## BH\_CROSSROADS\_TO\_REDMOND\_RIDGE\_MSC

UNDERGROUND FIBER INSTALLATION  
RIGHT-OF-WAY CONSTRUCTION PERMIT

City of Redmond  
Public Works - Right-of-Way

Approved  
Approved with Corrections noted  
Revision Required

**SCALE** HORZ: SEE SCALE  
VERT: 1:10  
**SHEET** 08 OF 17

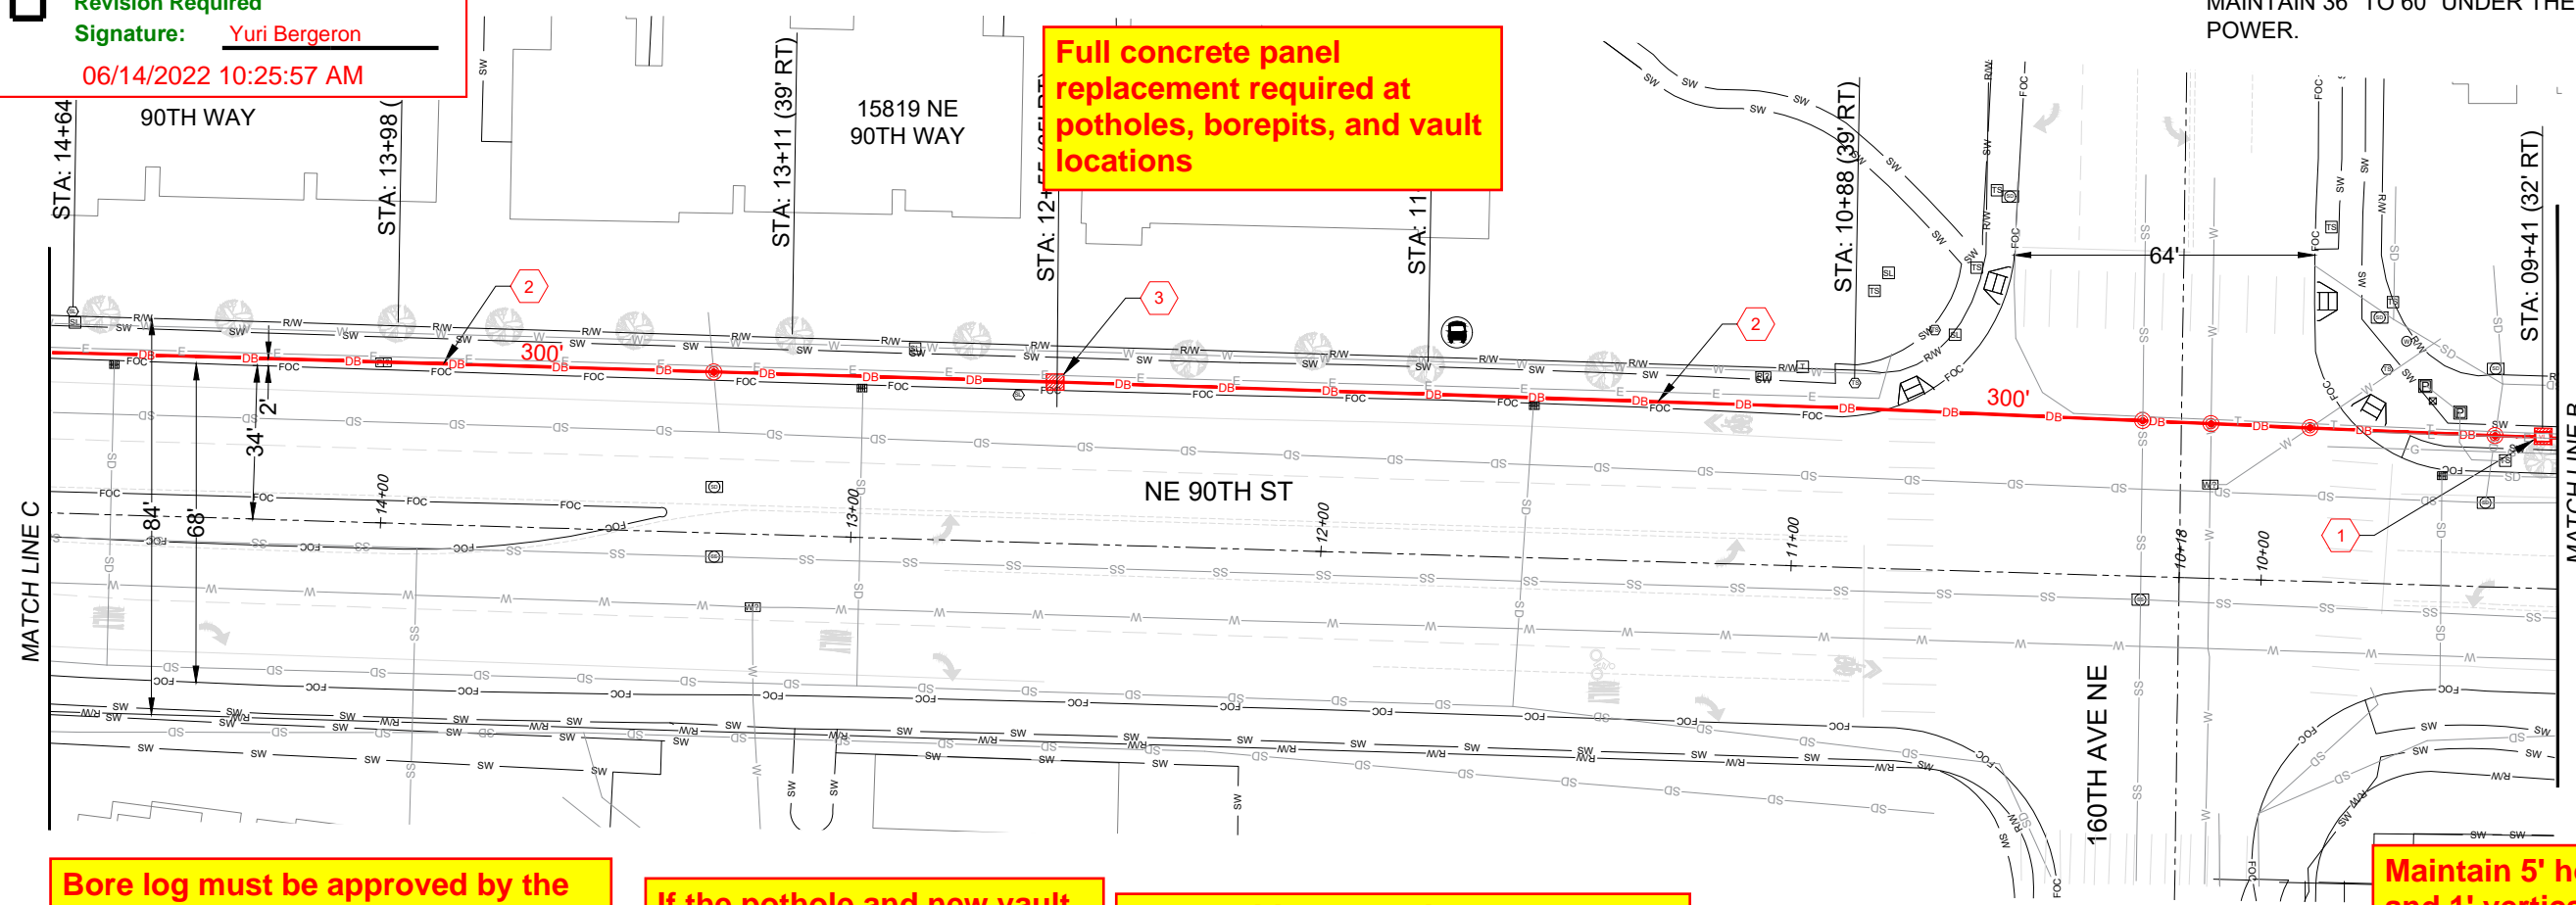
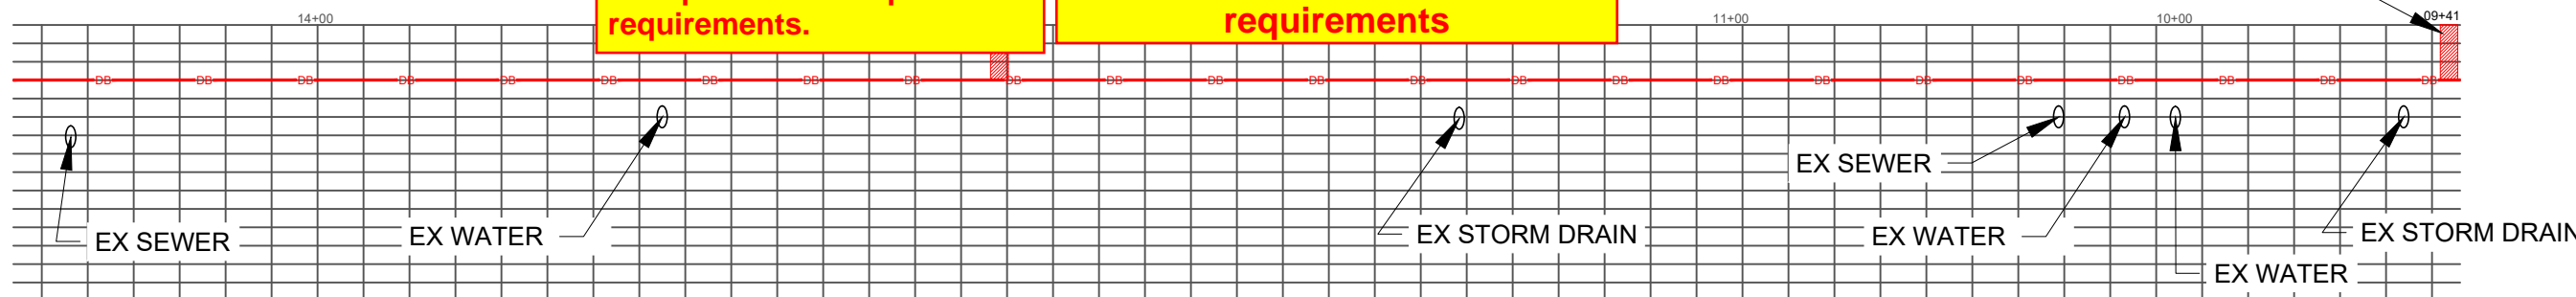
Bore log must be approved by the inspector before drilling can begin

If the pothole and new vault installation disturbs an existing ADA Ramp it must be replaced to compliance requirements.

All utility crossings shall be potholed prior to drilling to verify depths and clearance requirements

Maintain 5' horizontal and 1' vertical clearances from city utilities/structures

Potholes, Trench Restoration, Asphalt & Sidewalk Replacement & landscape restorations shall be per City Standard Details 201, 202, 203, and 303 and COR Inspector instructions.

Any additional potholes not depicted on these plans must be approved by the inspector

The city is in talks to arrange an agreement for utilizing city conduit crossing NE 90 St. This approval is for boring only at this time due to incoming roadway improvements this summer.

SHEET 10 OF 17

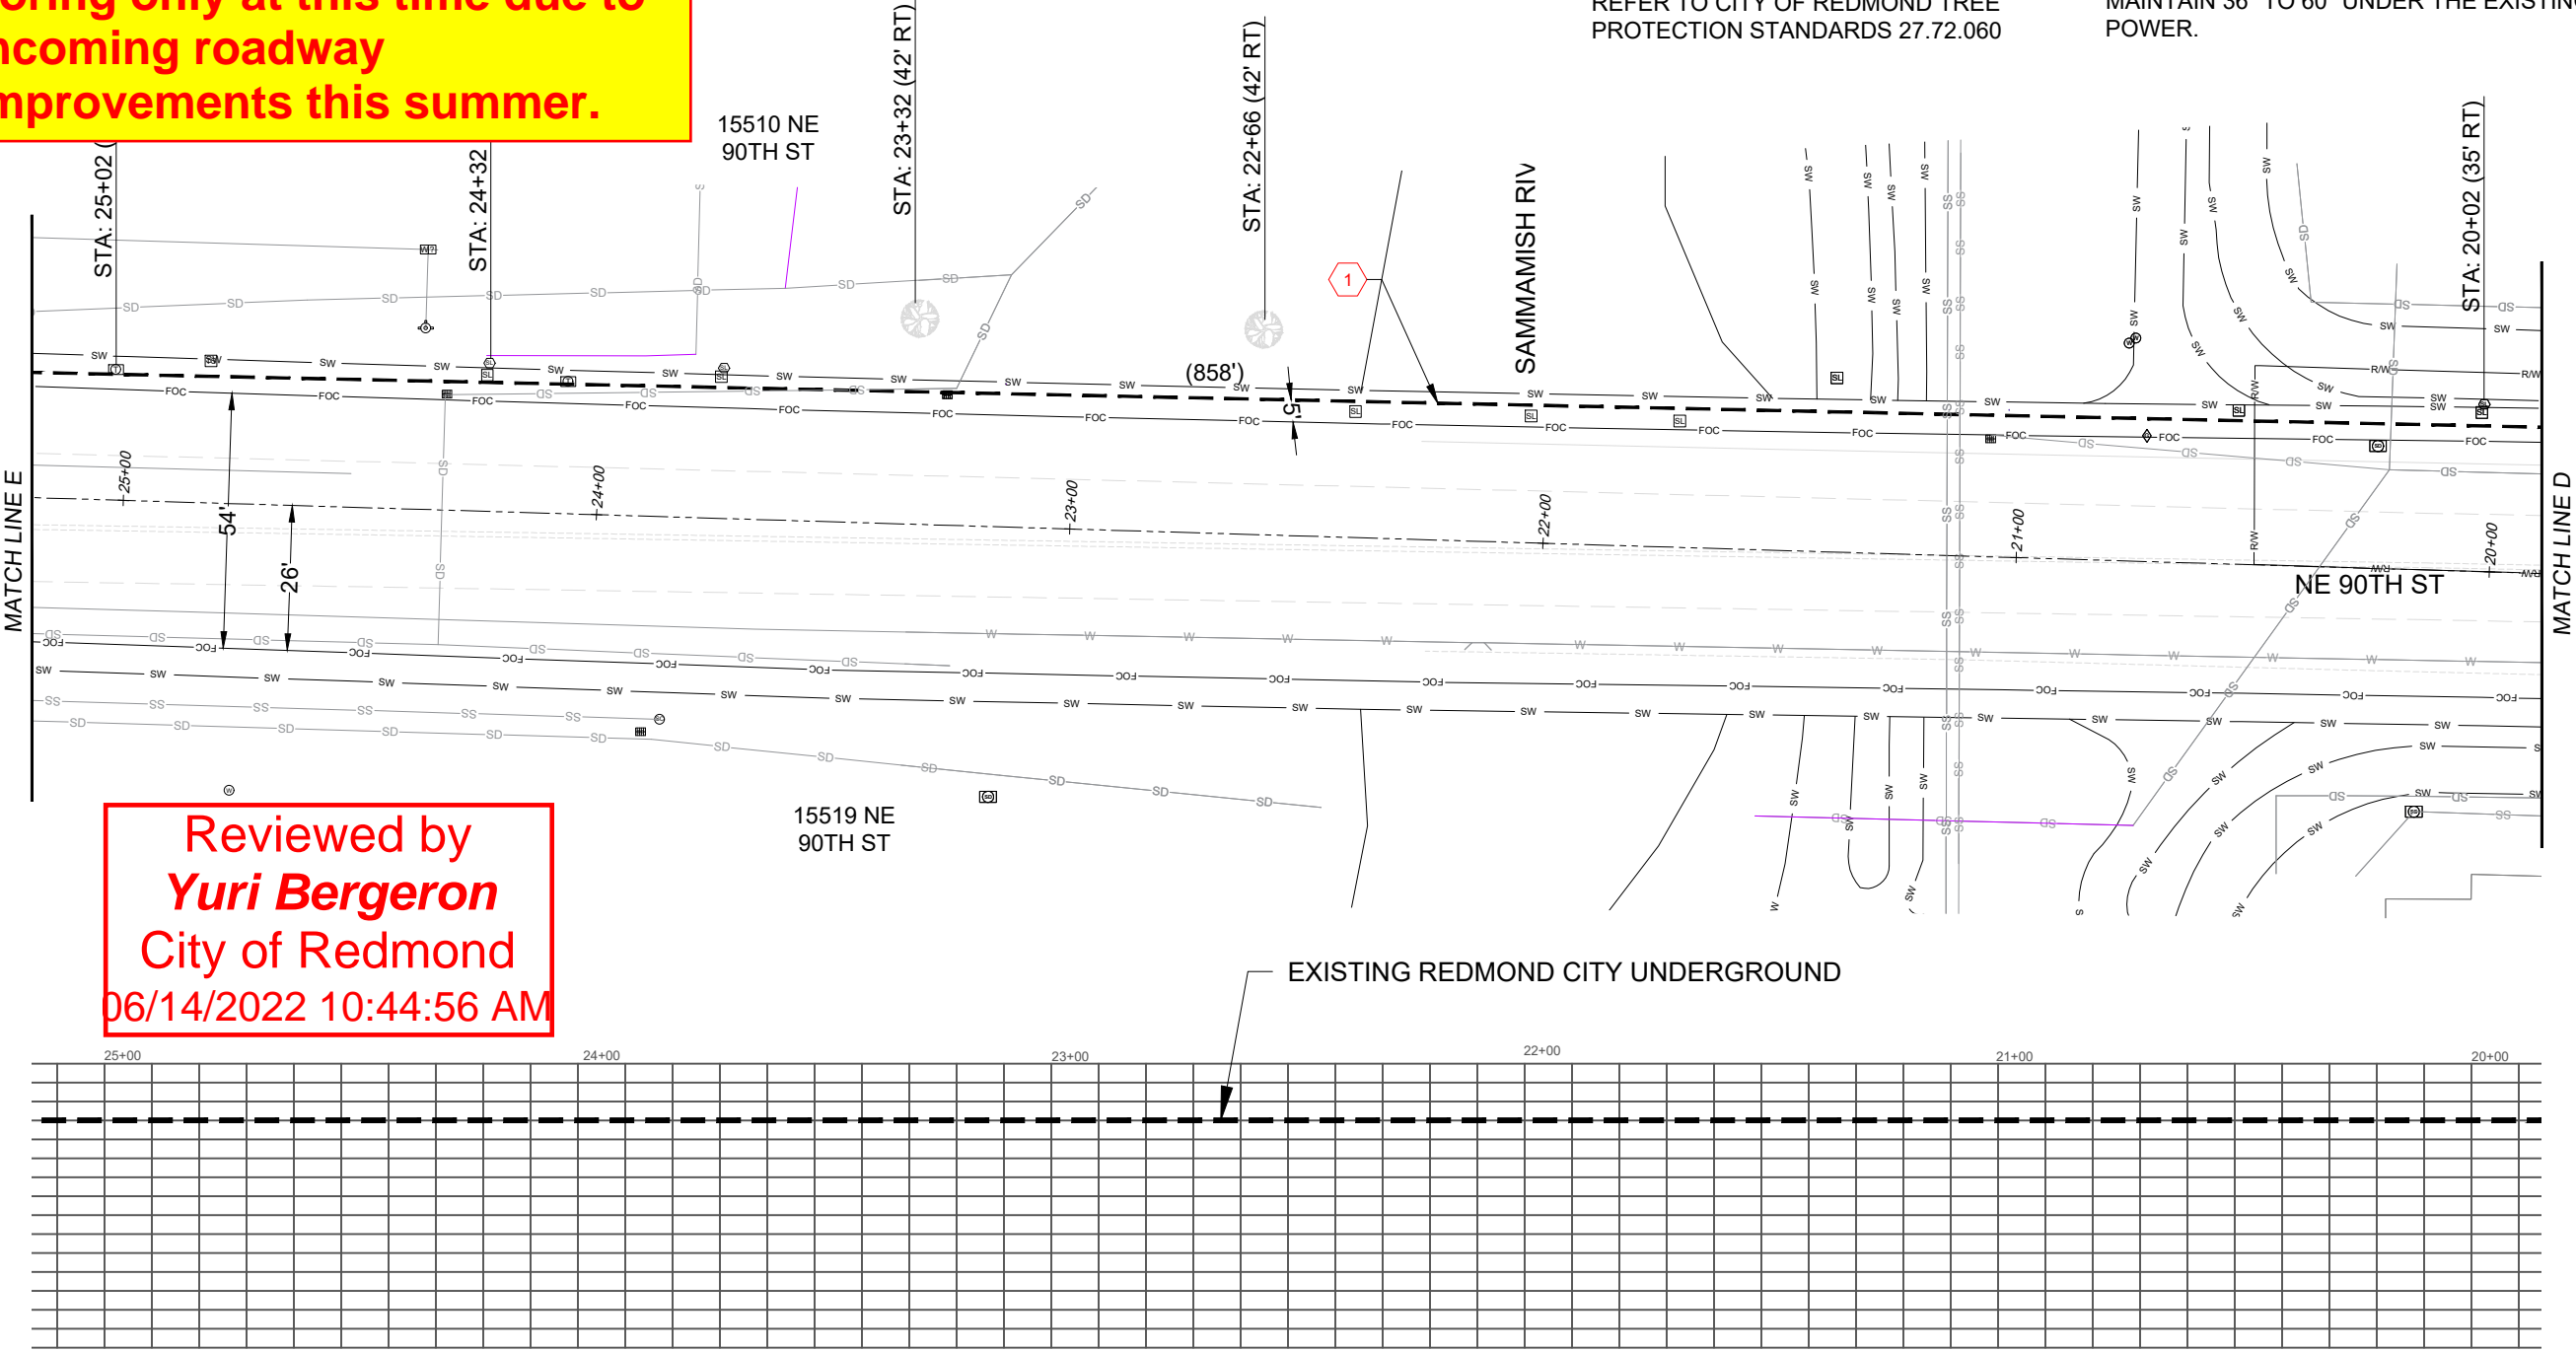
The city is in talks to arrange an agreement for utilizing city conduit crossing NE 90 St. This current review is for boring only at this time due to incoming roadway improvements this summer.
